PLANS AND DOCUMENTS referred to in the PDA DEVELOPMENT APPROVAL

Approval no: DEV2016/759
Date: 25 January 2017

AMENDED IN RED

527 GREGORY TCE

1 | Staging Plan

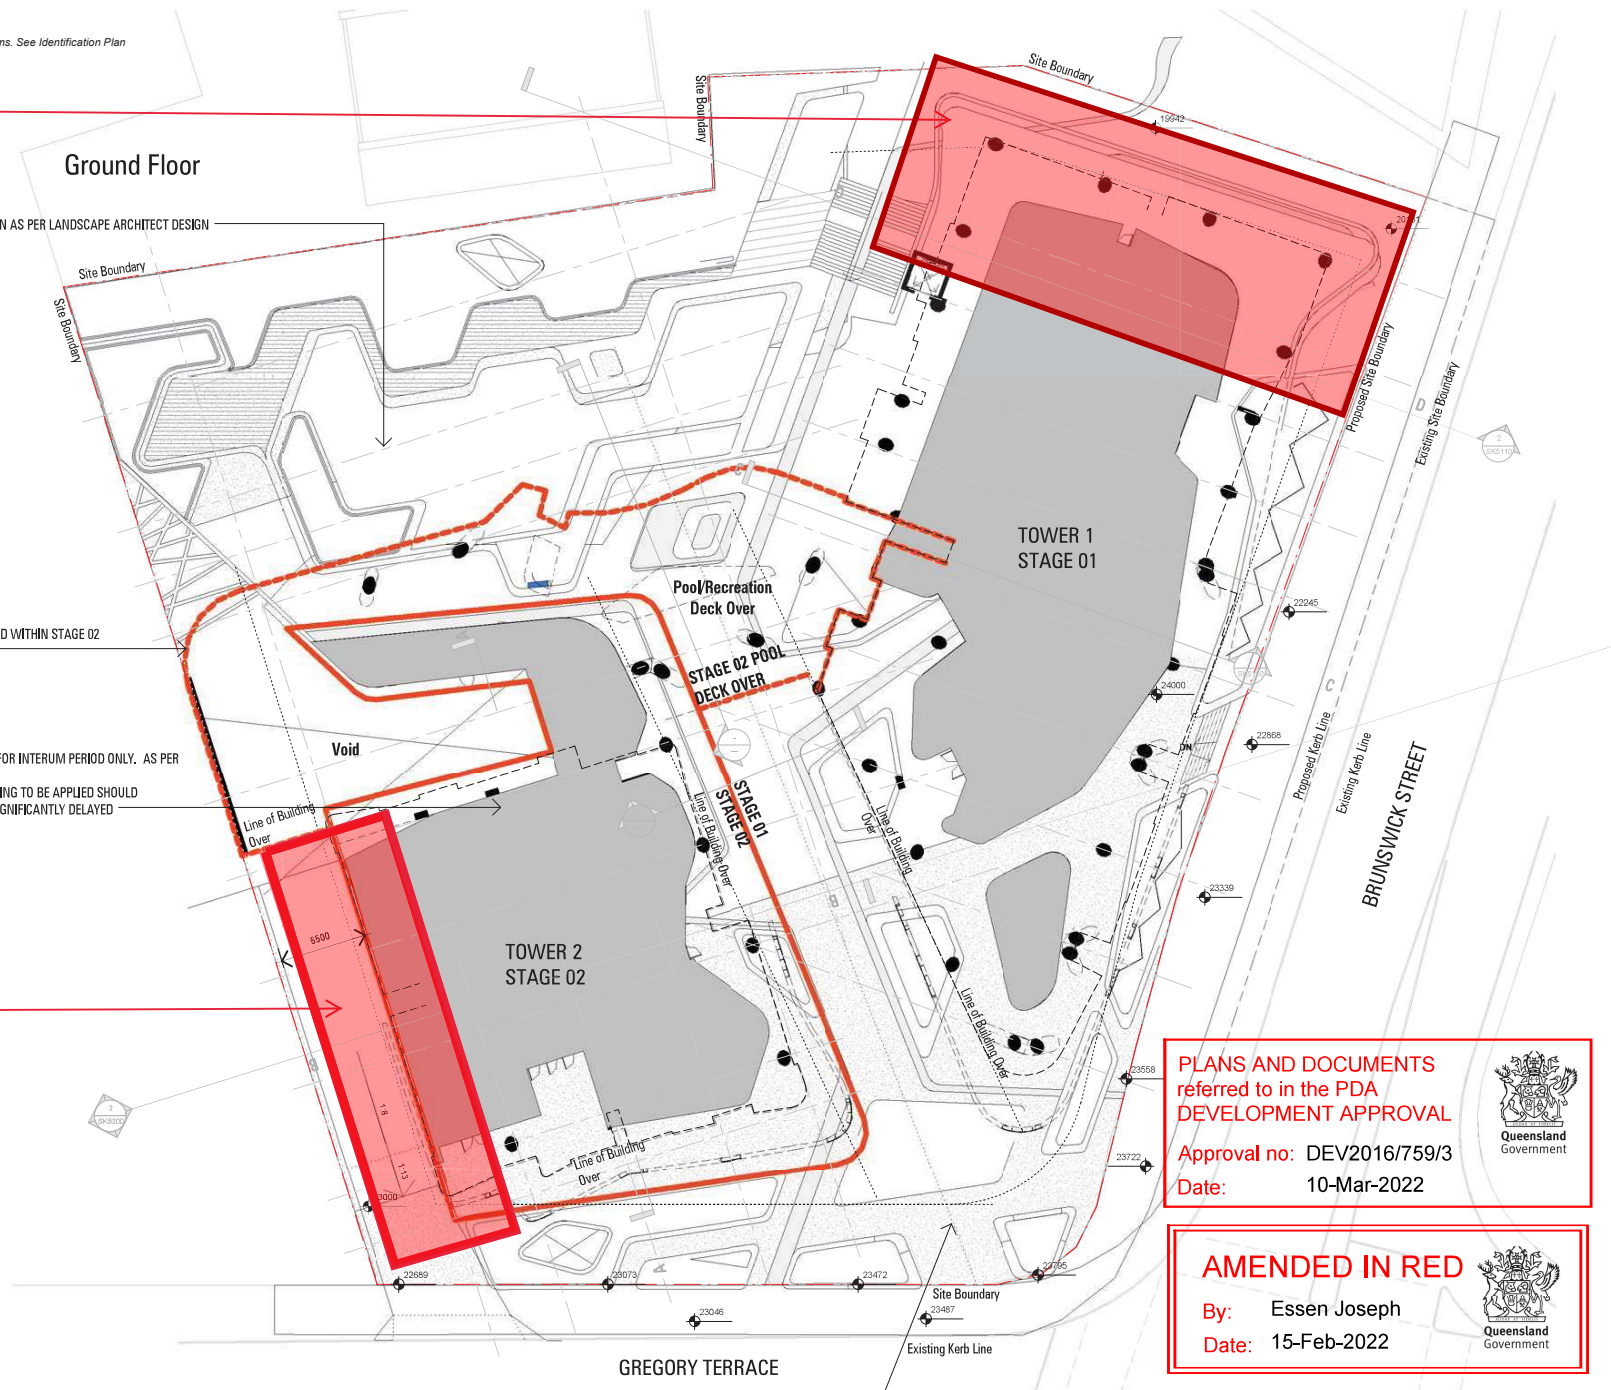
Increase building setback to 9m from boundary.
Reconfigure apartments / building design to achieve setback.

Reconfigure outlook of habitable spaces of all apartments on the eastern boundary towards Gregory Tce and the Drill Hall (e.g. through the use of a fin-shaped floor plate, providing solid walls to the north-east, but large windows looking north and south).

1 | SECTION BB - TOWER 2 STAGING PLAN

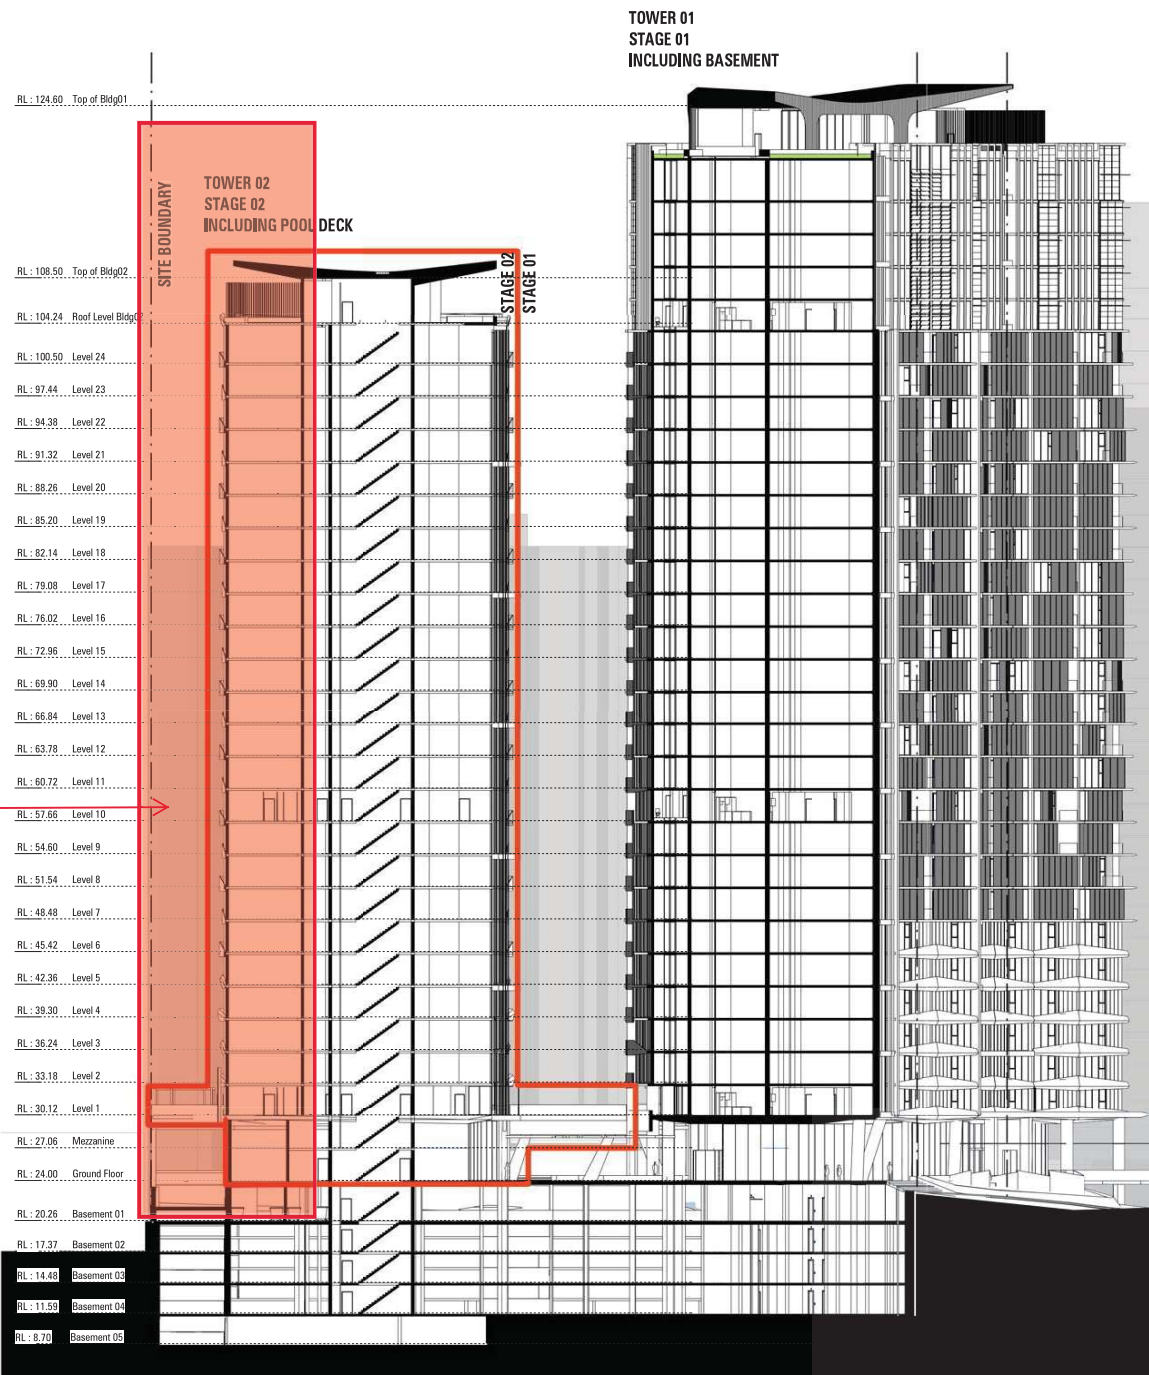
Reconfigure outlook of
habitable spaces of all
apartments on the
eastern boundary
towards Gregory Tce
and the Drill Hall (e.g.
through the use of a
fin-shaped floor plate,
providing solid walls
to the north-east, with
large windows looking
north and south).

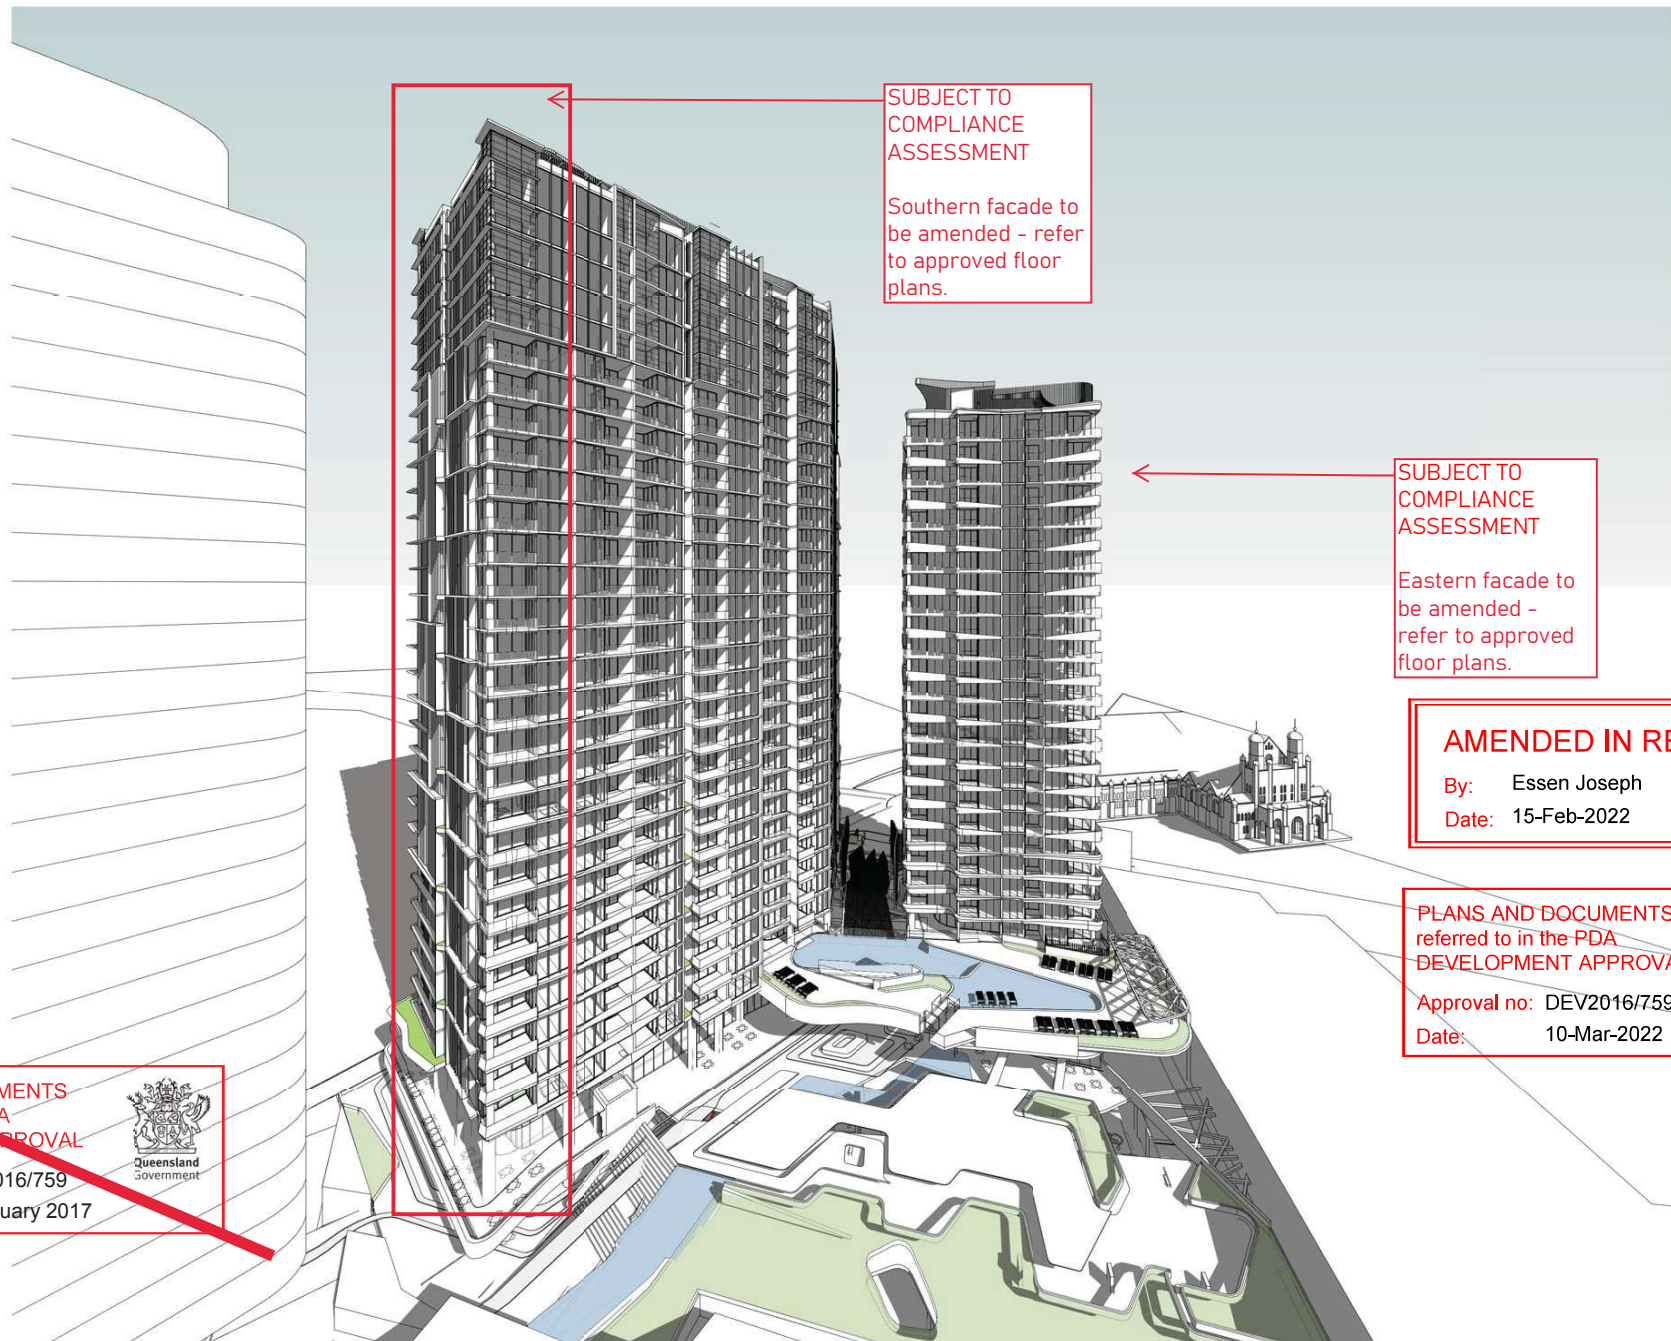
Southern facade to
be amended - refer
to approved floor
plans.

Basement 01

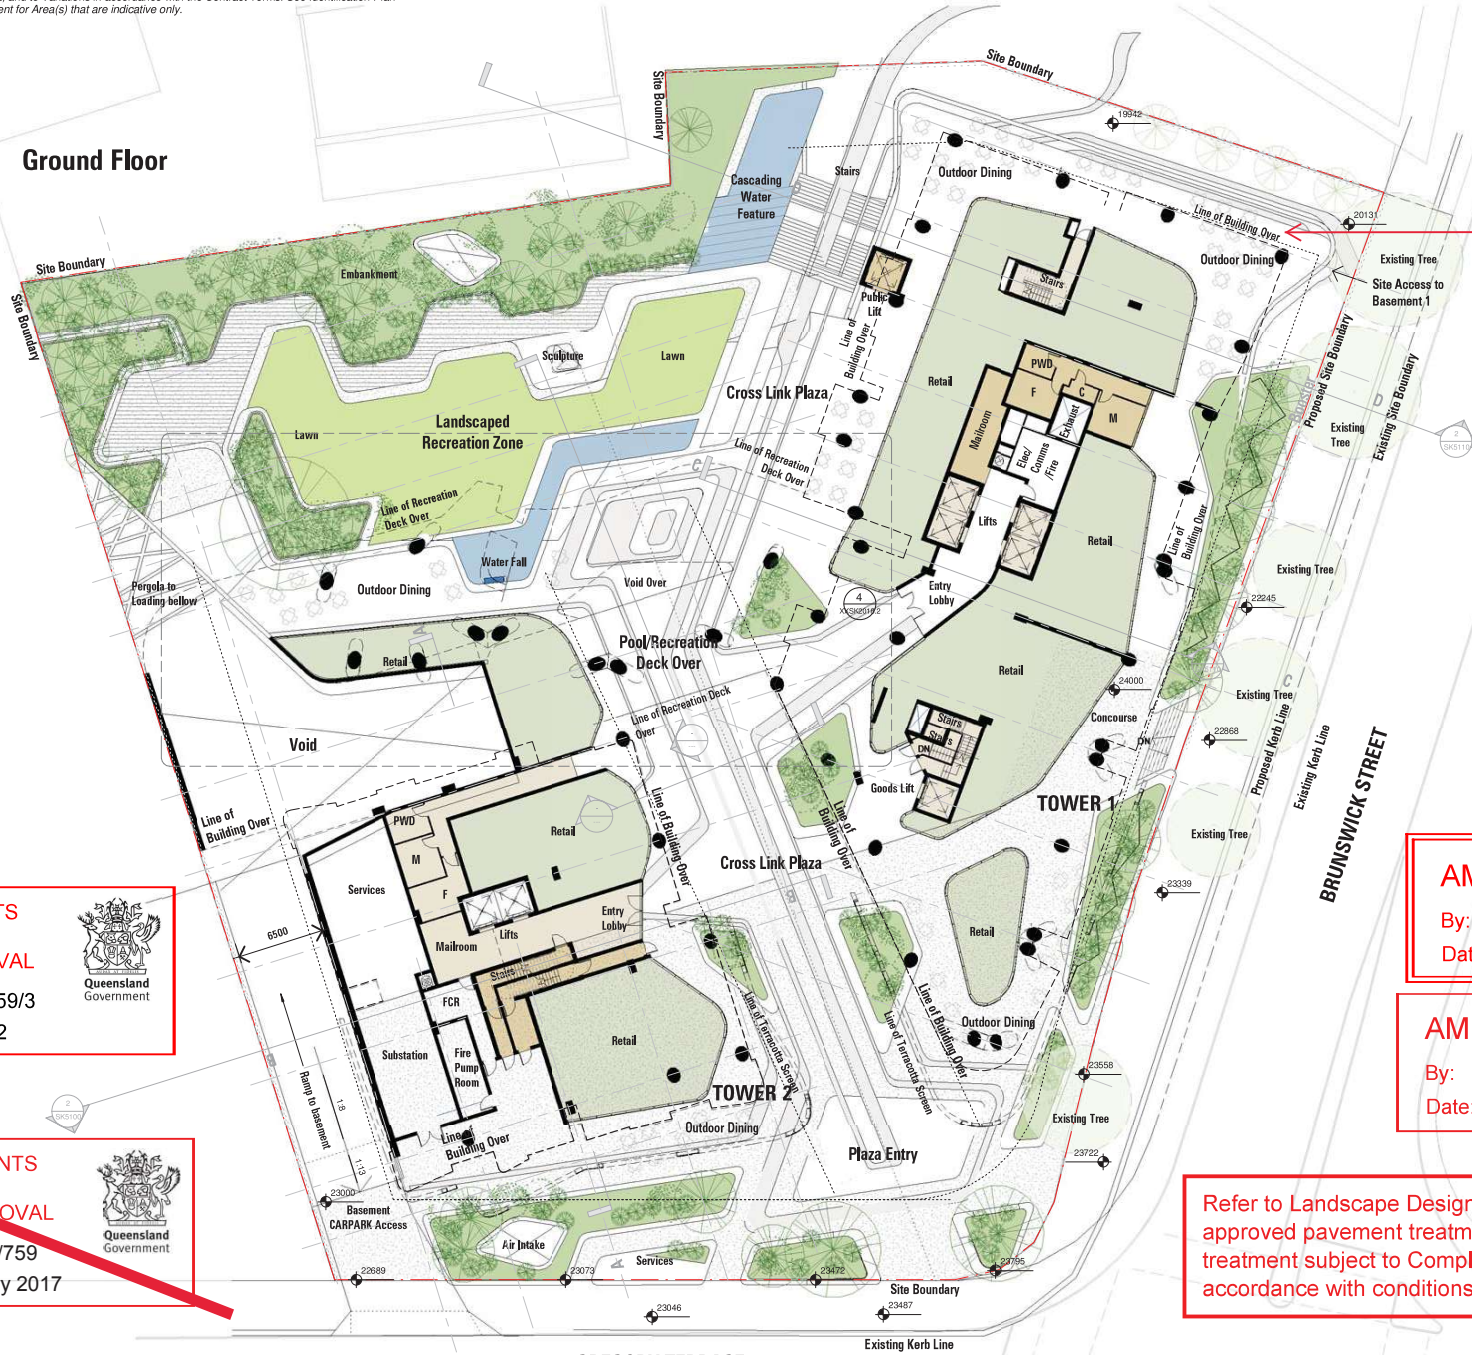
Basement design to accommodate planting of mature trees above, commensurate with BCC deep planting requirements.

Compliance assessment documentation to demonstrate viability of establishing and maintaining trees in good health.

See also the approved Landscape Design Intent for species selection, and its implications for planter design.

Ground Floor

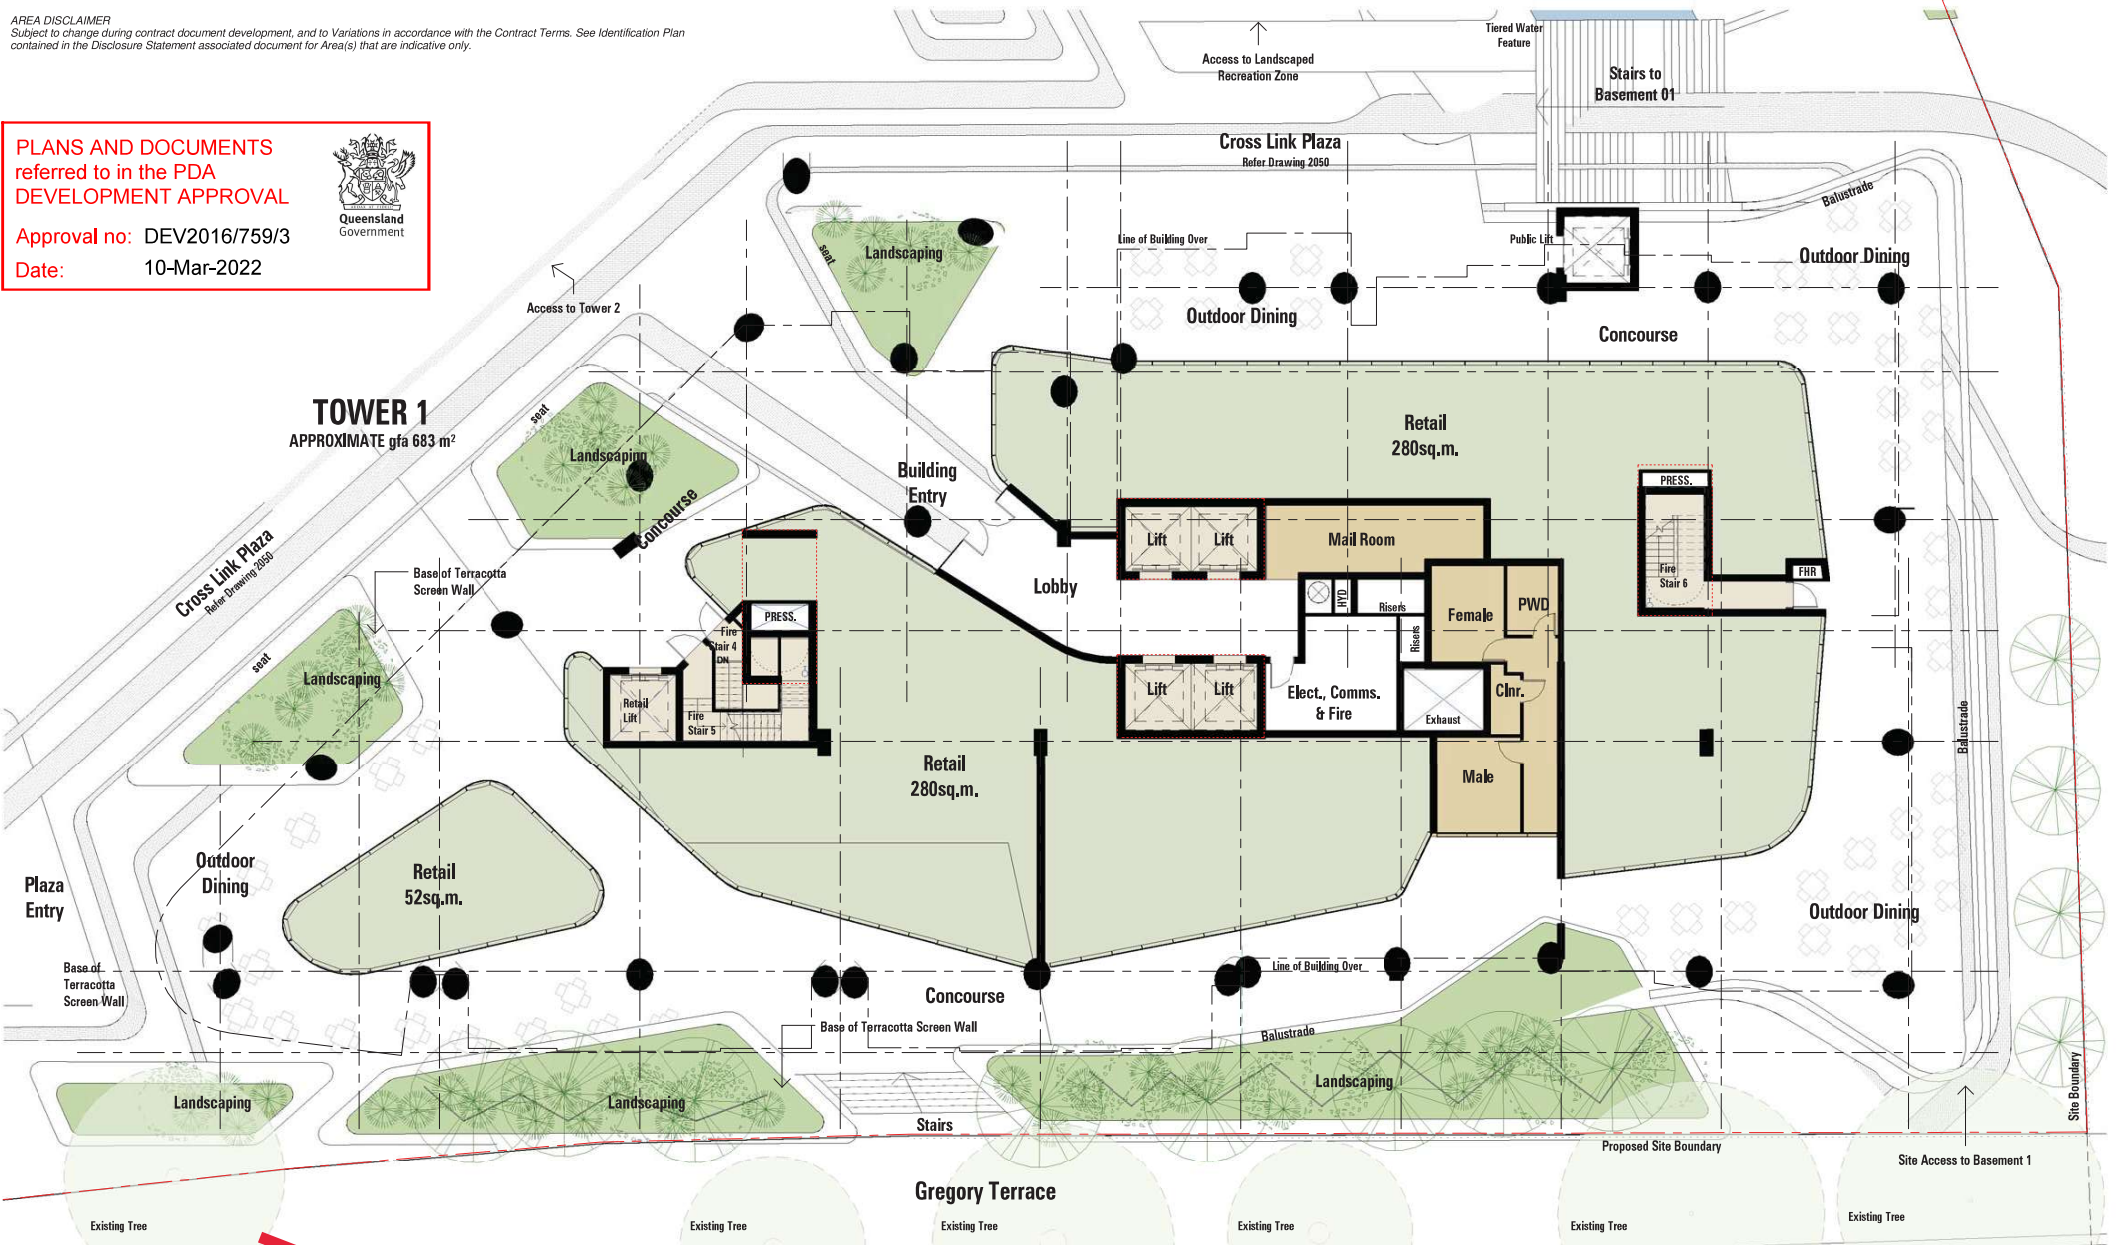
Retain existing tree, having regard for depth and spread of roots, and amend basement design to achieve retention. Amend lower basement levels if required.

Increase building setback to 9m from boundary. Reconfigure apartments / building design to achieve setback.

Refer to Landscape Design Intent, prepared by Form (as amended in red) for tree retention requirements.

Refer to Landscape Design Intent, prepared by Form, for approved pavement treatment for Ground level. Pavement treatment subject to Compliance Assessment in accordance with conditions of approval.
